REVIEW
AIR QUALITY IMPACT ASSESSMENT
MT OWEN CONTINUED OPERATIONS
PROJECT

NSW Department of Planning & Environment

29 April 2016

Peer Review

Figure 1: Skew and NW winds between modelling data (right) and all data (left) for SX8

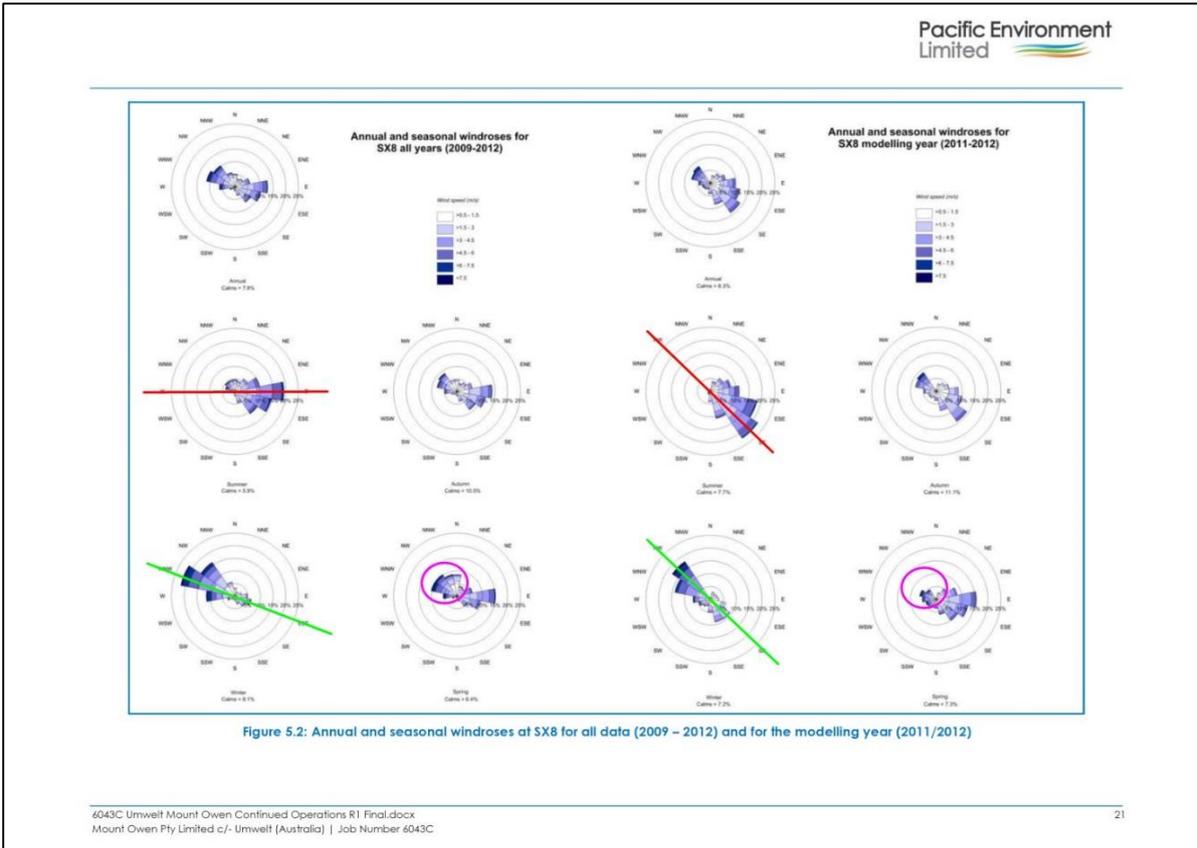
The issues raised in the review regarding the weather data are illustrated in the **Figure 1** and **Figure 2** below:

These issues have the potential to underestimate the frequency of potential impacts to the east-southeast of the Project, towards the area most sensitive to potential impacts from the Project (due to the apparent bias in the selected meteorological data relative to the typical conditions) and also the scale of potential impacts (due to low dust levels in the modelled year).

Further analysis of the monitoring data should be performed to clarify the significance of this issue in so far as it may affect the scale and frequency of impacts.

Figure 3: Proponent’s analysis of potential skew in wind direction and wind speed in the modelling data

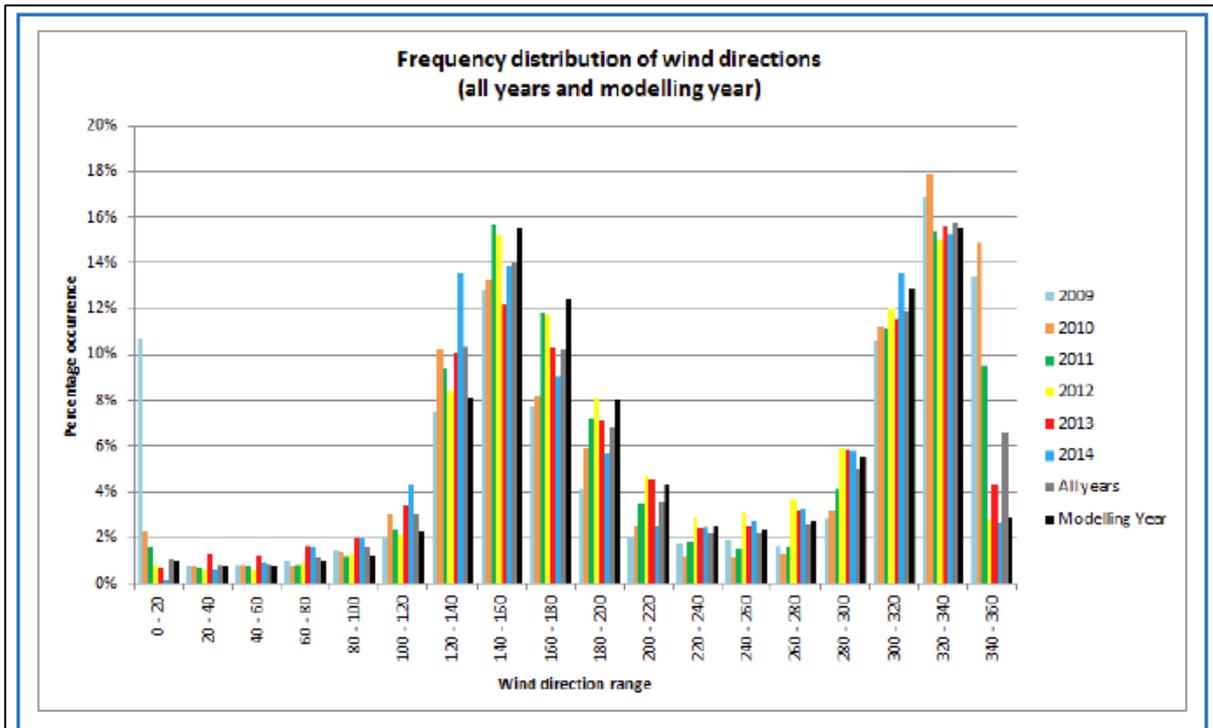
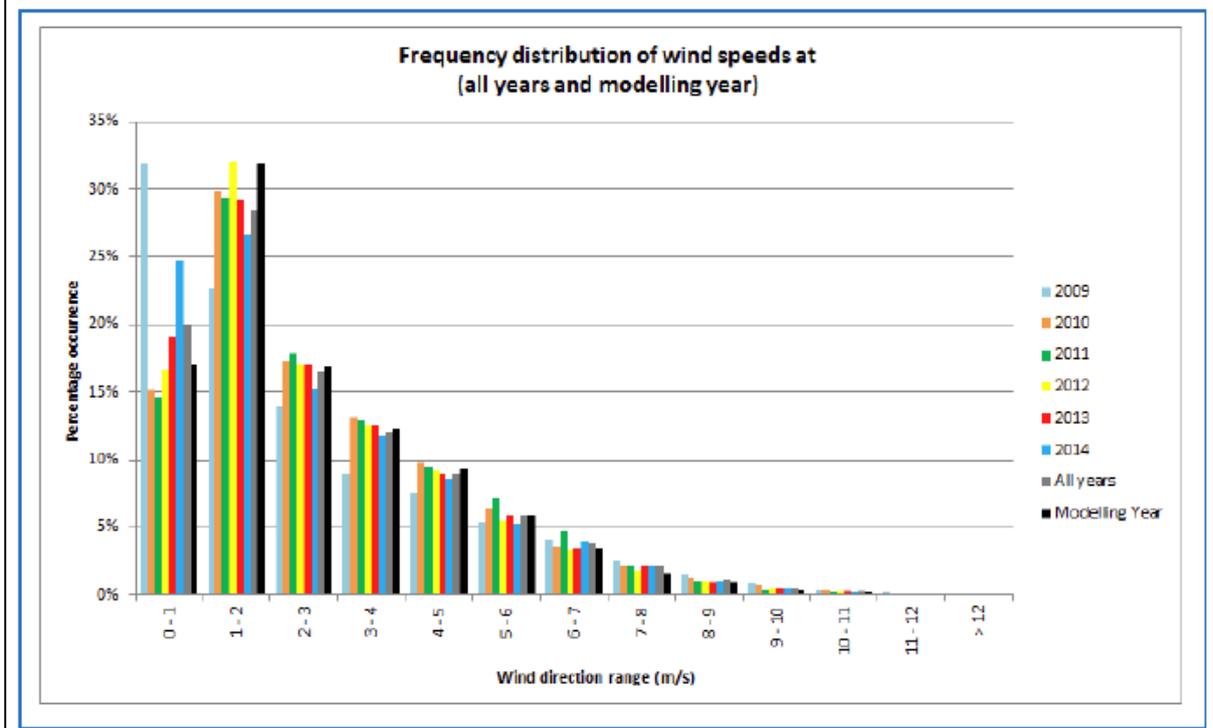
Figure 3 provides a graphical summary taken from the proponent’s later 3 March 2016 analysis. This shows that the modelled year is generally similar to the other years, apart from having above average south easterly winds (140 to 200 degrees) and below average north winds (340 to 360 degrees).

Figure 4: Comparison of modelled data with the average and 95th percentile confidence interval of all data – SX8

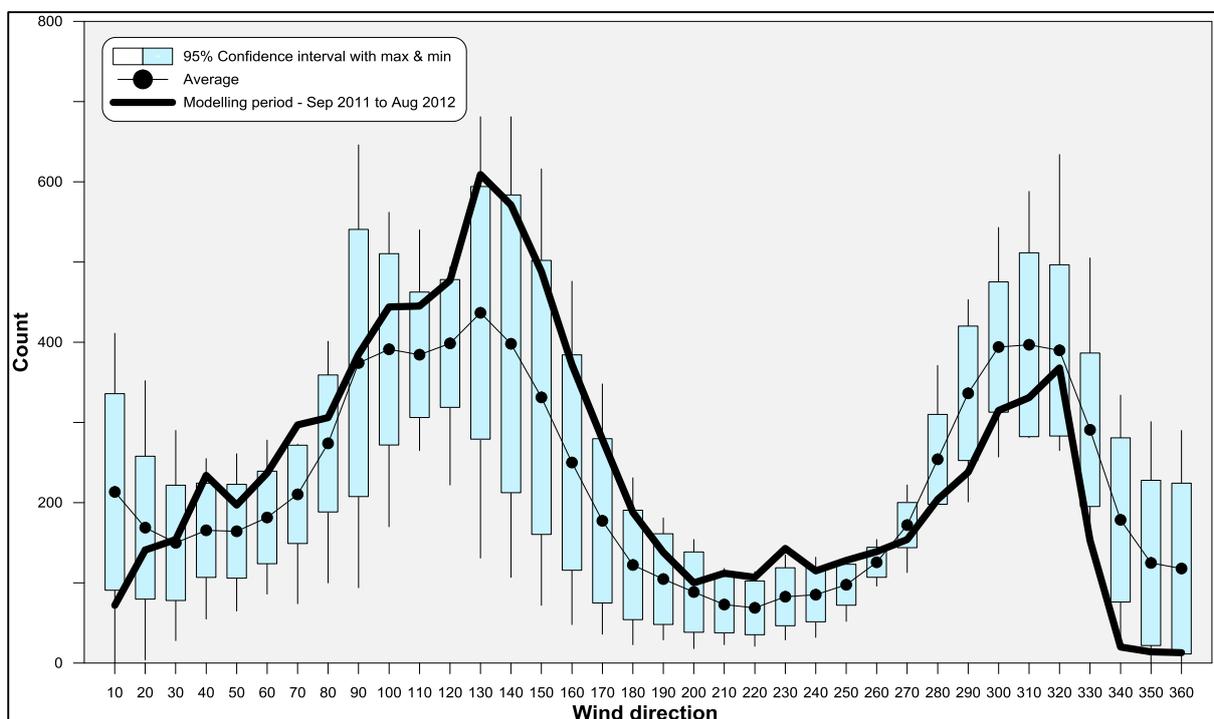
Figure 4 shows that the selected year has data at the edge of the (wide) confidence interval for south easterly winds and outside of the confidence interval range for north winds (350 to 10 degrees).

An important finding is that although winds from the northeastern quadrant occur less than on average, and are outside the relatively wide 95th percentile confidence interval in some cases, the more frequent, (and important in regard to the most potentially impacted receptors), north westerly winds (310 to 330 degrees) lie within the 95th percentile confidence interval, with 300 to 400 hours of such data.

Figure 5: Comparison of modelled year with each available calendar year – SX8

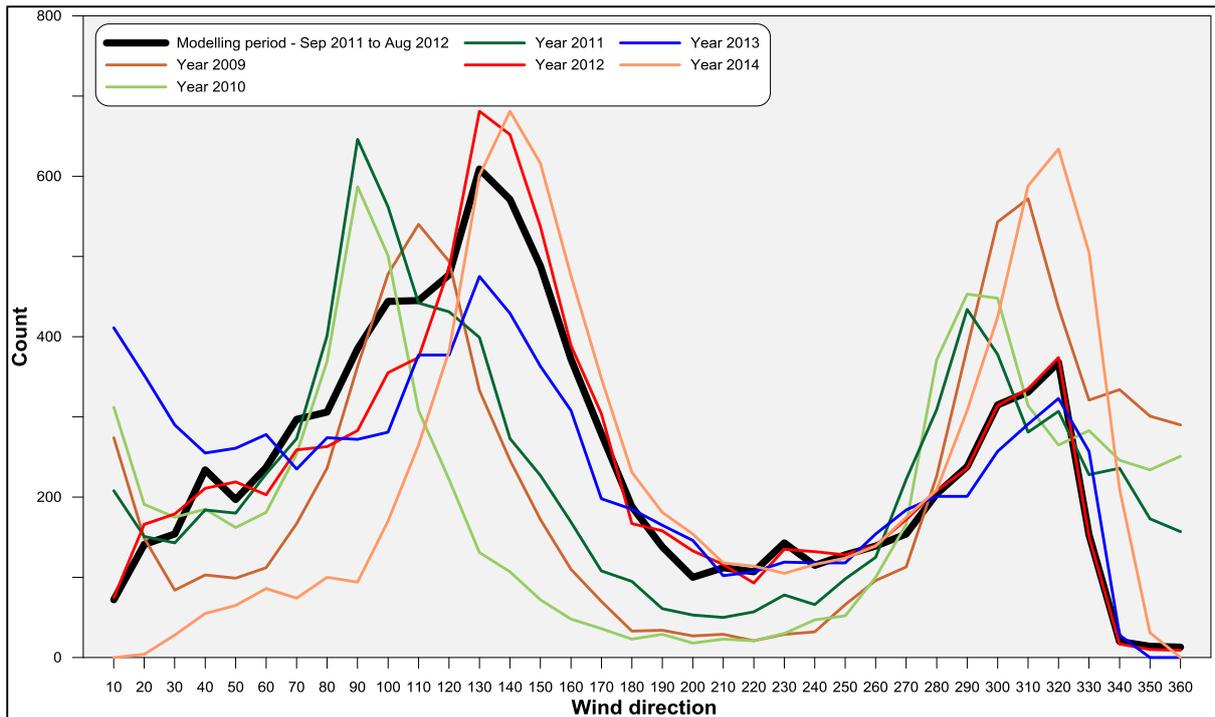
Figure 5 shows that all of the years of data at station SX8 show an unusually large spread of wind directions relative to the average, and that there may be quality issues with the data.

Figure 6: Data comparison – SX13

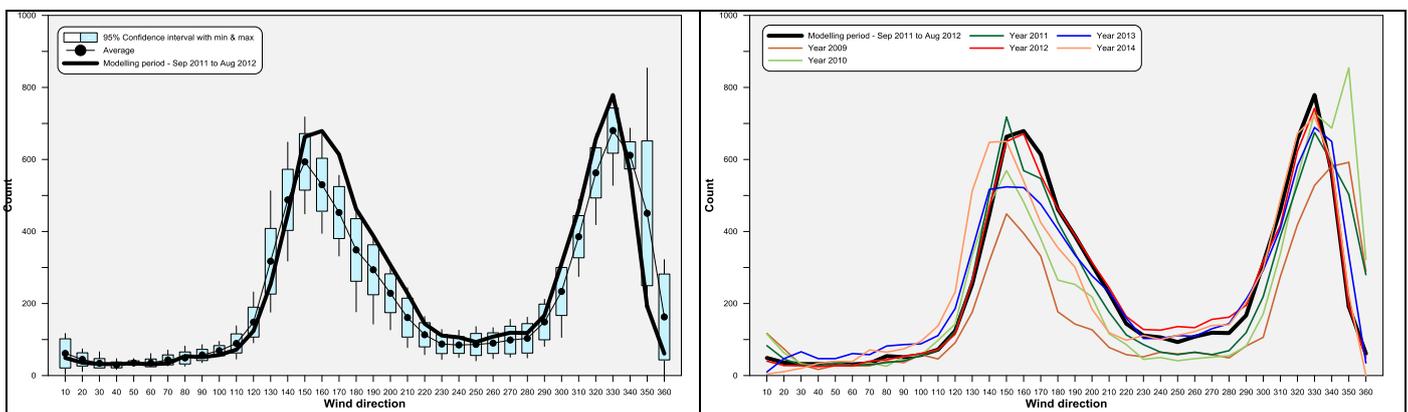
The unusually wide range in the data at station SX8 is evident in comparison with the equivalent data for station SX13 for the same period, as presented in Figure 6. The figure shows a much smaller range in the 95th percentile confidence interval, approximately twice as much data in the northwest segment (700 to 800 hours), and much less variation in wind direction between years.

Figure 7: Comparison of annual wind roses for SX8 (top row) and SX13 (bottom row)

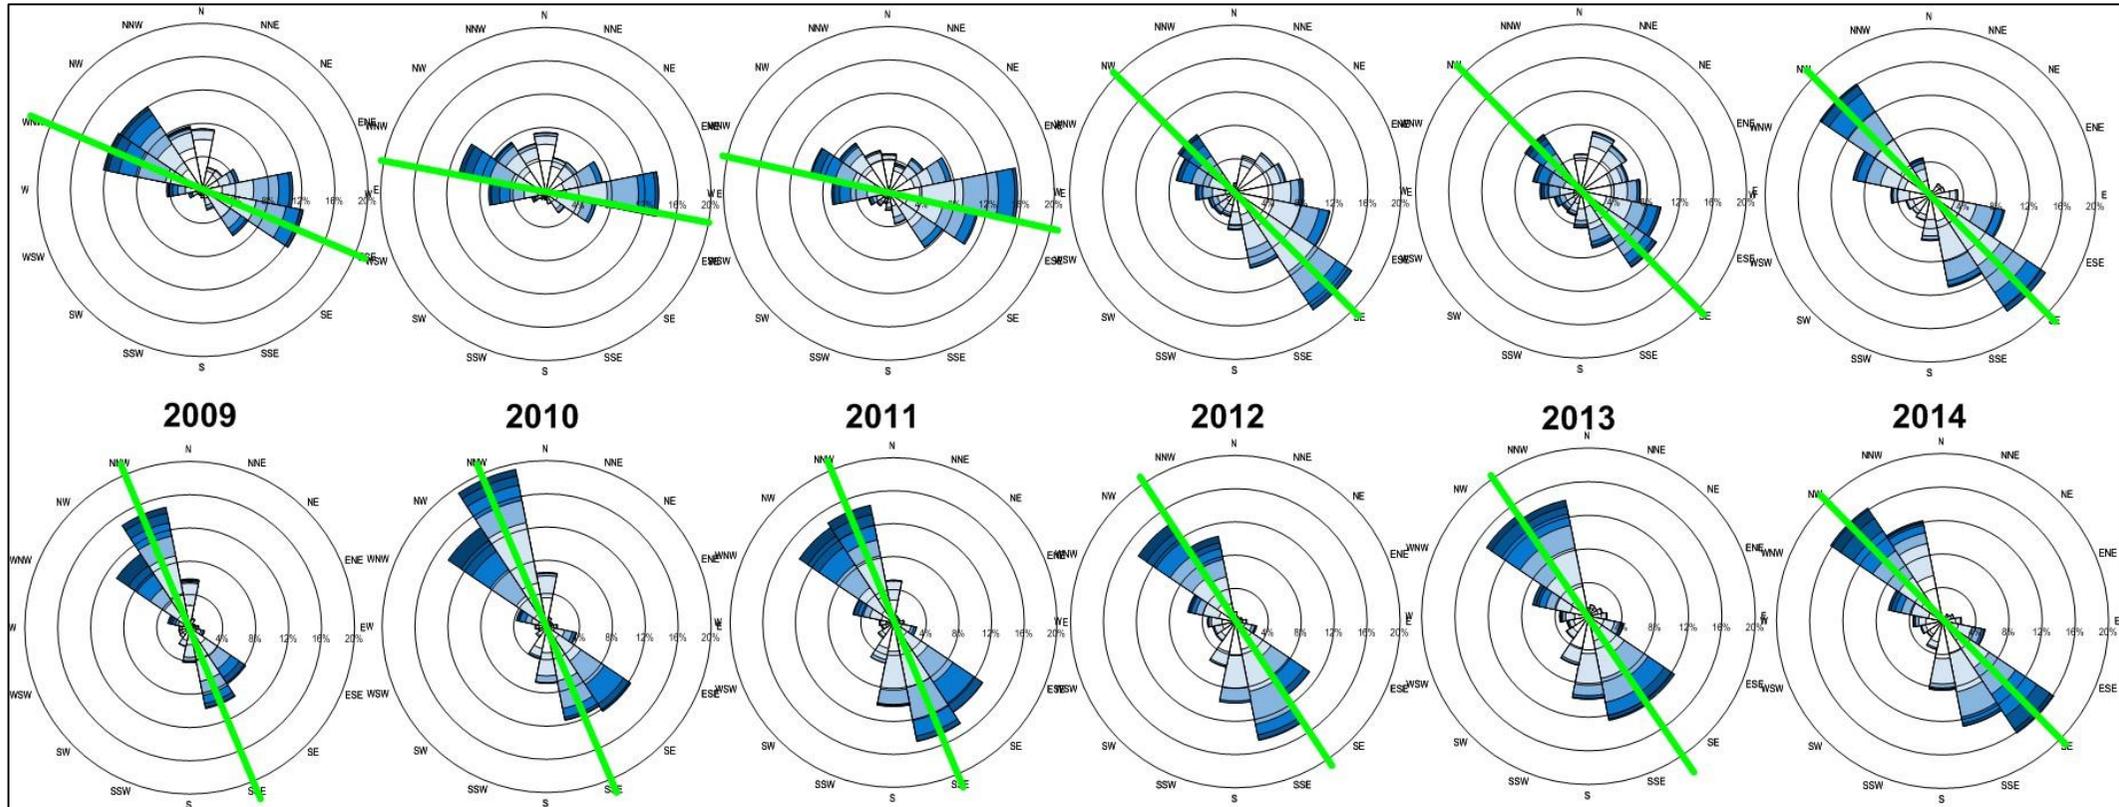
The data in **Figure 7** show that there is a significant change in the wind directions being recorded at station SX8 between 2011 and 2012 (the chosen modelling period) and a narrower range of wind direction for the dominant winds in 2014.

In contrast, the station SX13 data show relatively consistent results in all years that are similar to the station SX8 data in 2014.

Figure 8: Comparison of SX8, SX13 and modelling data near the likely most affected receptors to the southeast of the Project - period of modelling 2011-12

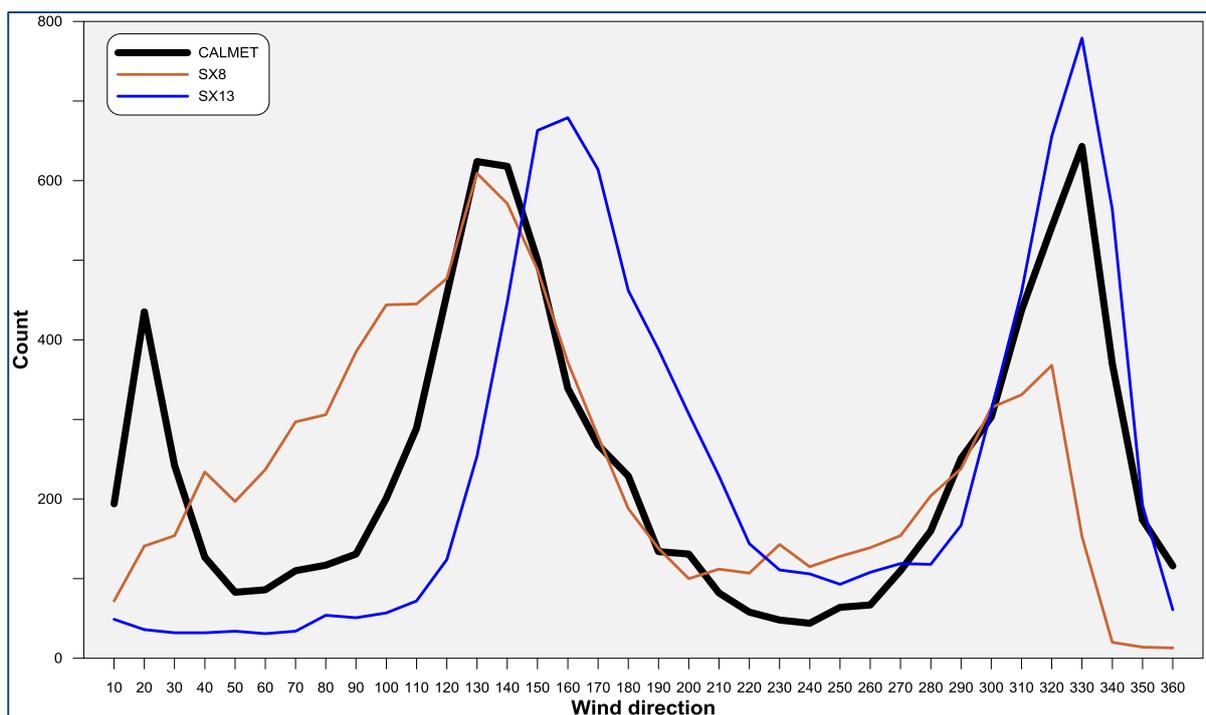
These output meteorological data are used directly in the modelling of dust impacts and are examined in **Figure 8**. The figure shows that at the receptors of most interest, the data generally lies between the measured SX8 and SX13 station's data, and most importantly, for the critical north westerly winds the modelled data are closer to the SX13 station's data set, and include a reasonably representative fraction and spread of north westerly wind conditions.

Other relevant aspects to note are that the data used in the modelling include winds from the north-northeast (e.g. from 20 degrees) which are not present in either the station SX8 or SX13 data. The full independent analysis (not shown) reveals that these are generally low speed winds in a narrow range of direction, and are potentially due to katabatic wind flows down the general alignment of the creek valley near the receptors of most interest. This indicates that the meteorological model is potentially responding to the local terrain, and the data therefore are likely to be reasonably representative of the actual weather conditions near these receptors.

In summary, it is clear that there is an issue with the data quality for the station SX8 data (generally) and specifically in the chosen modelling period.

In **Figure 8**, the review examined whether the modelled data (black line) was reasonably representative of the actual conditions which may occur near the cluster of receptors to the southeast of the Project. The figure shows that the data used in the actual modelling reflect the data at station SX13 (containing

valid data). The figure also indicates that the modelled data also include low wind speed flows down along the valley at this location, as would be expected in reality.

Figure 9: Pollution rose for SX9 PM₁₀ monitoring data using SX8 weather (left per proponent's Figure 4) and SX13 weather (right, per proponent's Figure 5)

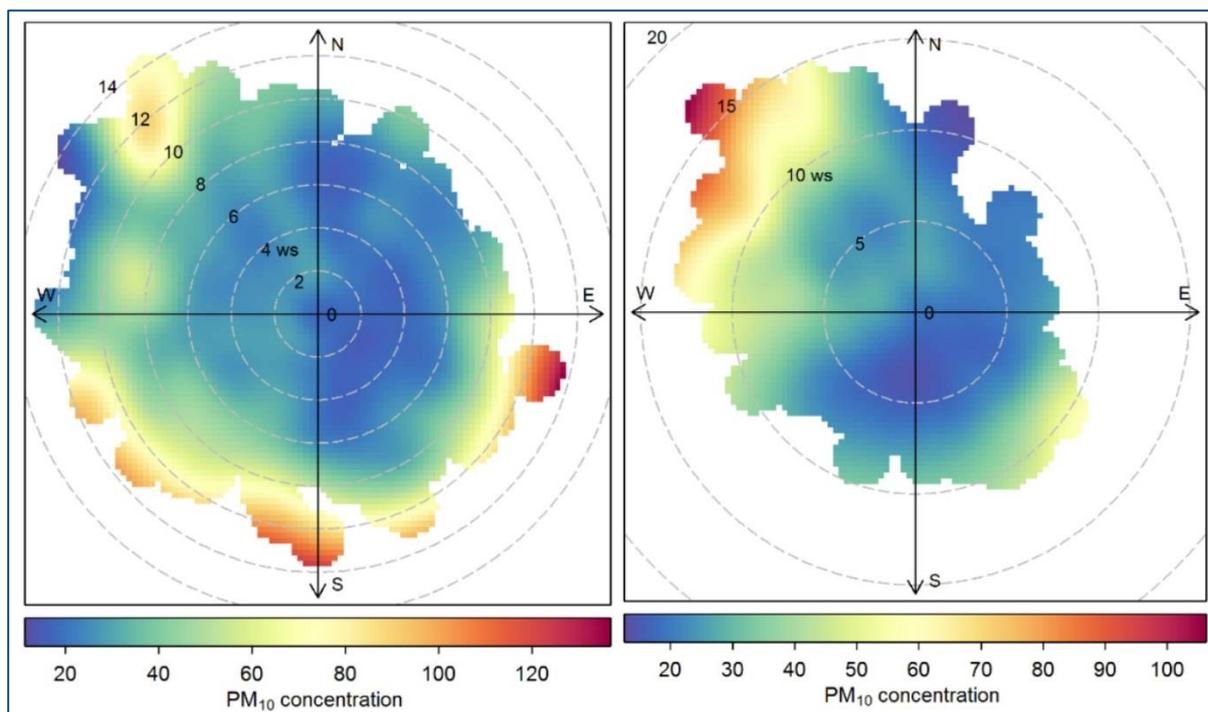
These plots clearly show that the choice of meteorological data (SX8 or SX13) has a significant bearing on the results (e.g. seen by comparing the proponent's Figure 4 with Figure 5 in its March analysis, as presented in **Figure 9**).

The plots derived using the problematic SX8 weather station data (e.g. left side of **Figure 9**) are not accepted as valid by the review, but the plots based on station SX13 data (e.g. right side of **Figure 9**)

are considered to be reliable, especially when considering the generally good agreement between the locally modelled weather data and the SX13 weather data (see **Figure 8**).

Figure 10: Running annual average PM₁₀ concentrations at Mt Owen Monitoring Sites (Fig 5.5 of AQIA)

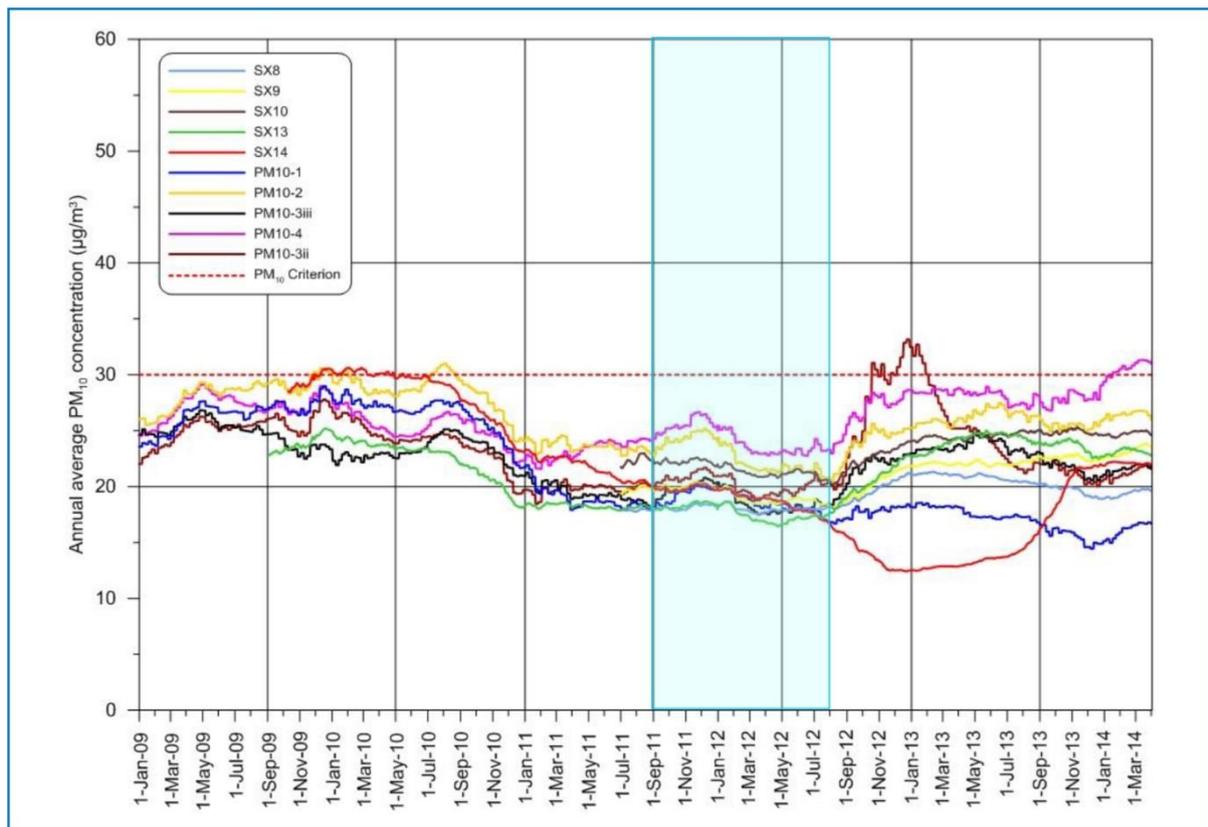
Corresponding monitoring data analysis of the running annual average PM₁₀ (see **Figure 10**) indicates that the chosen year for modelling typically contains generally low dust levels relative to the other years available. The blue shaded box indicates the selected modelling period which is 1 September 2011 to 31 August 2012.

Two monitors in particular do not appear to provide accurate results, these are the PM10-1 (located to the northwest of the Project) and SX14 (located to the south of the Project in Camberwell) monitors. Monitor PM10-1 appears to move from having some of the highest to some of the lowest levels for the period reviewed. Monitor SX14 appears to operate incorrectly as it records even lower and higher levels than PM10-1, and reports unrealistically low levels in Camberwell. It is unlikely that the data from this monitor is valid during the selected modelling period, given that it shows a downward trend without the seasonal variability apparent in all of the other monitors.

The proponent however does not adequately respond to the issue of whether the background dust levels chosen for the review are representative of the actual case, given that the modelling period corresponds with low levels of measured dust in the ambient air (e.g. see **Figure 10**).
